Changes from the Original Design

The design of the Northern Access Road differs from the design previously approved as follows:

Golygfa/View 2

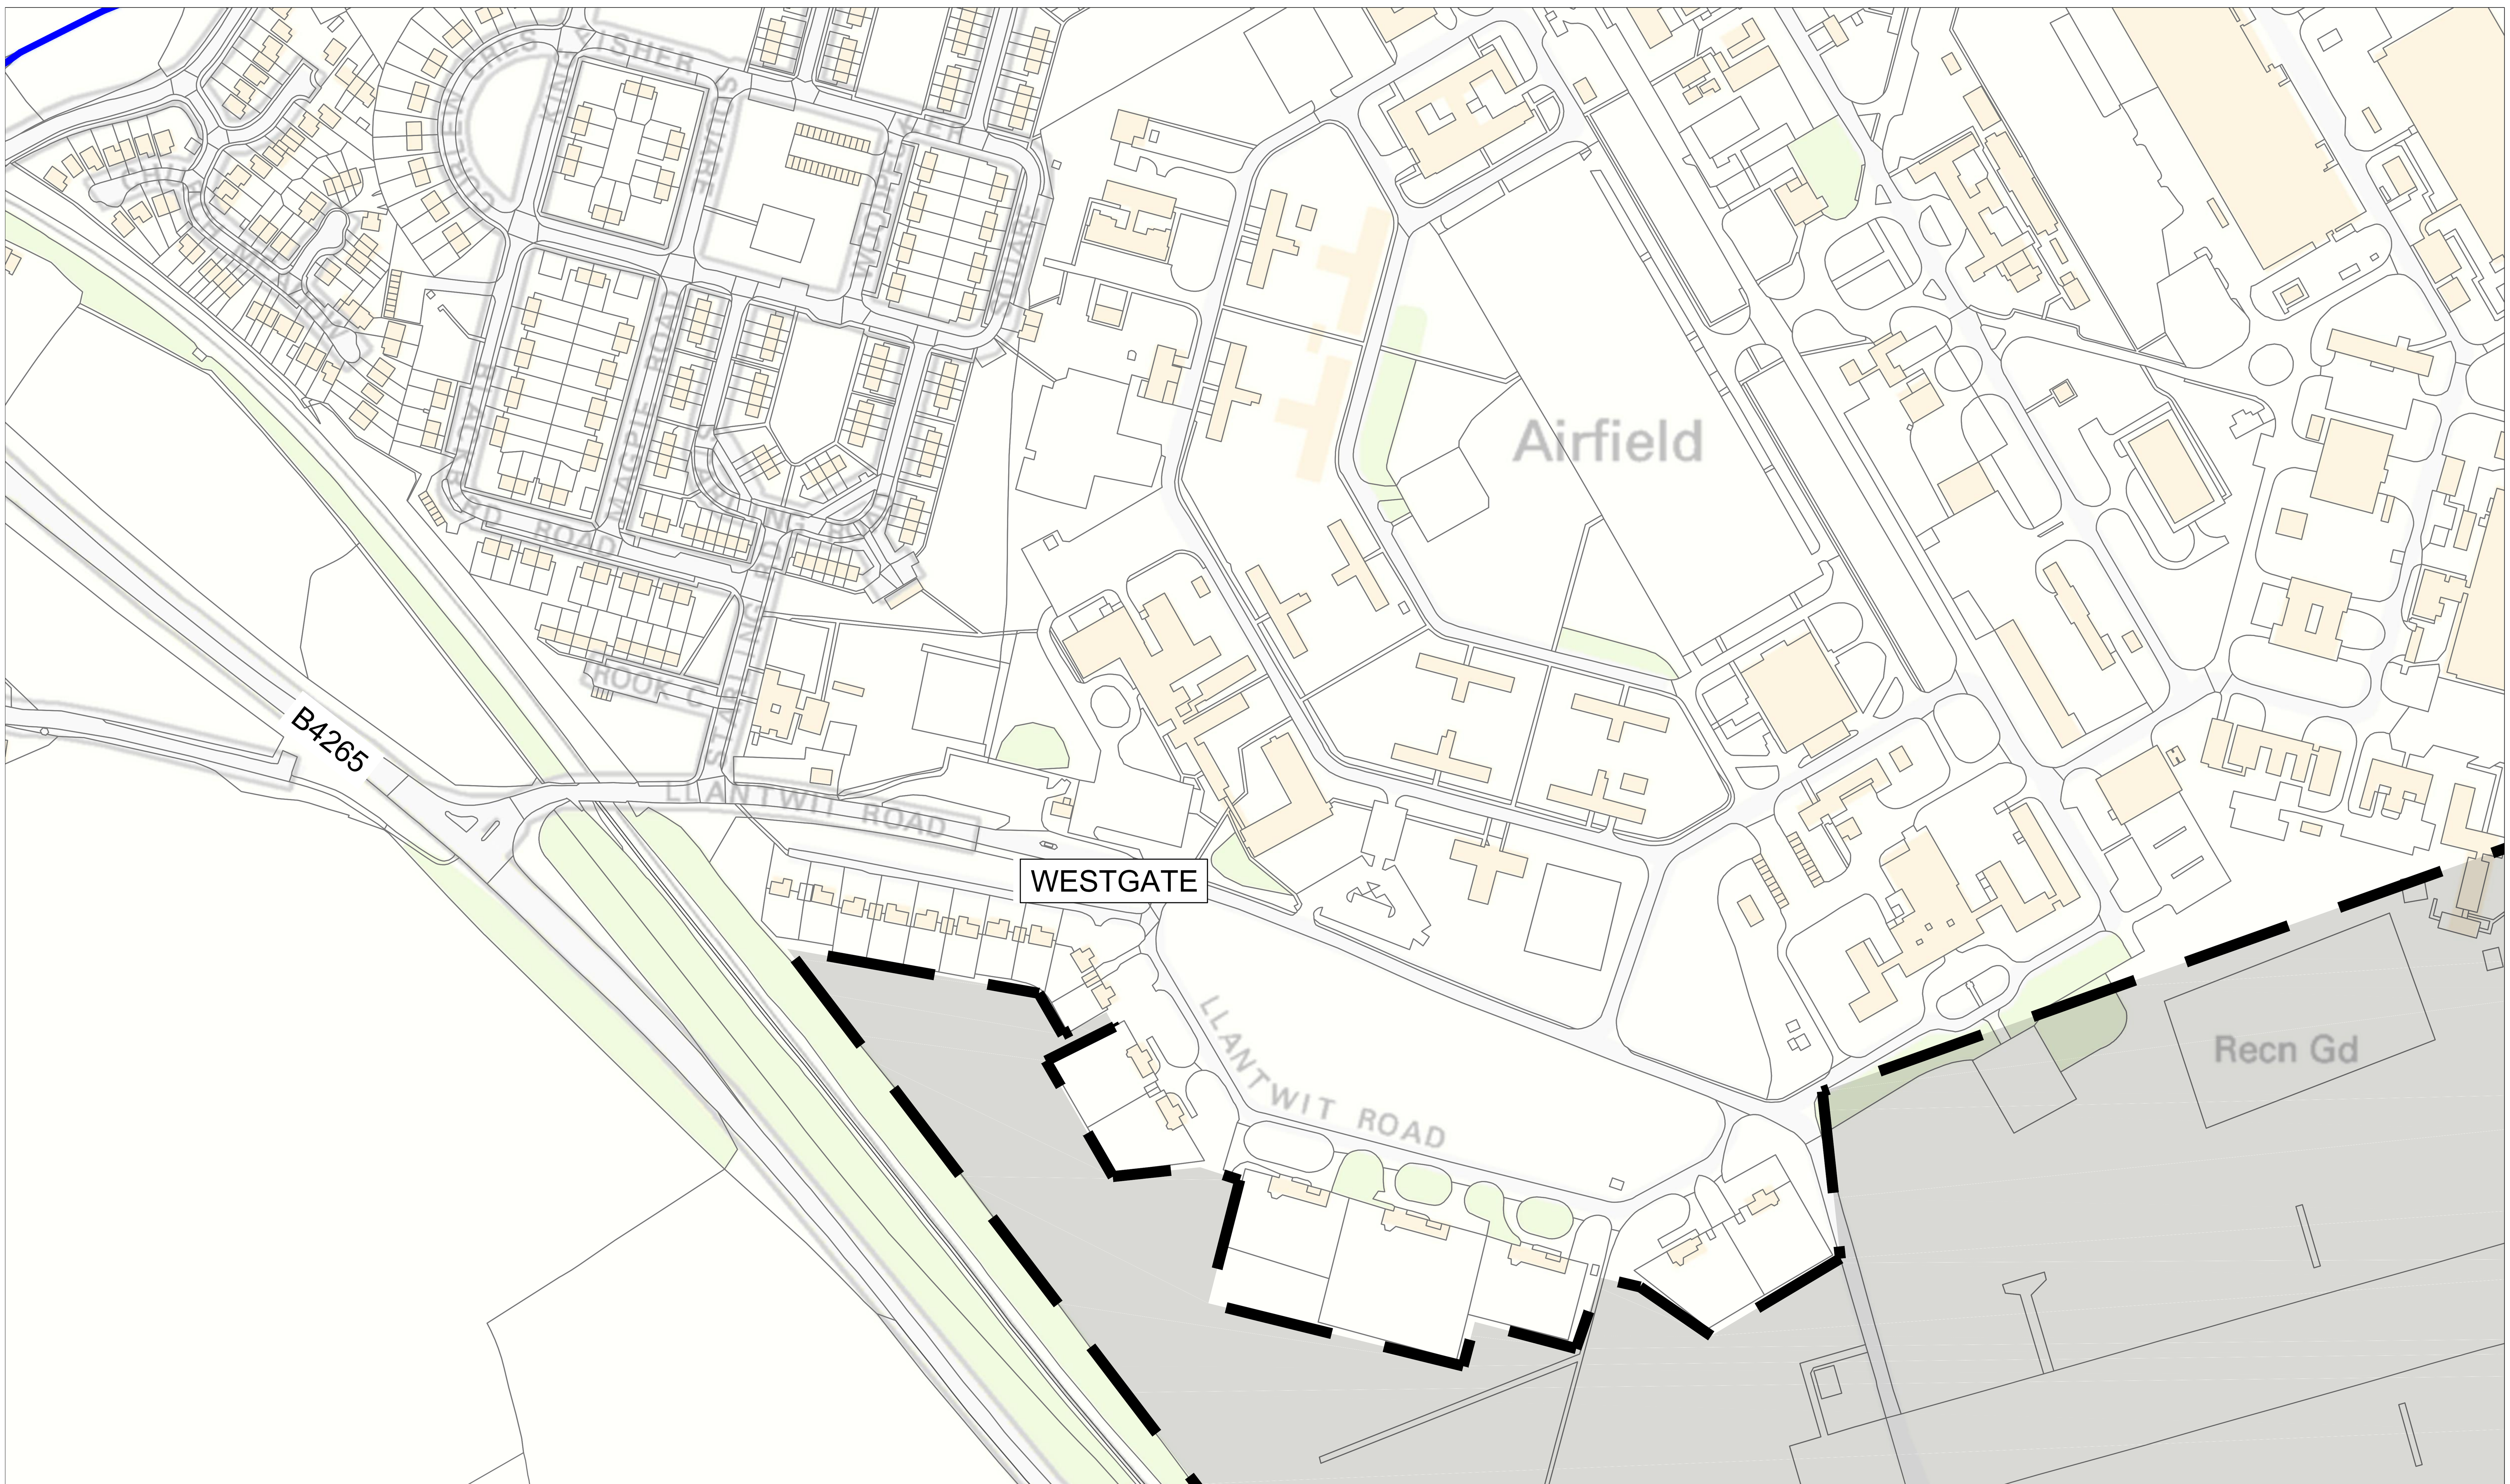
- **Bridge over Llanmaes Brook:** The design approved in 2009 included a bridge over Llanmaes Brook. This is no longer proposed. Instead, a smaller culvert will be constructed and the new road will act as a flood defence, protecting the downstream village of Boverton as well as Llanmaes upstream.

- **Vertical Alignment:** As a result of removing the bridge, the proposed road will be much lower than the original, now following the existing ground profile on a shallow embankment. At the western end the road will enter a cutting to connect with the B4265 at its current level.

- **Road width:** The previous design had to cater for large abnormal vehicles associated with the Defence Technical College. This required widened carriageways which are no longer necessary.

- **Access into the Aerospace Business Park:** The Northern Access Road will terminate at its eastern end at a new signalised junction near the existing super hanger. The new junction will provide gateway into the Aerospace Business Park.
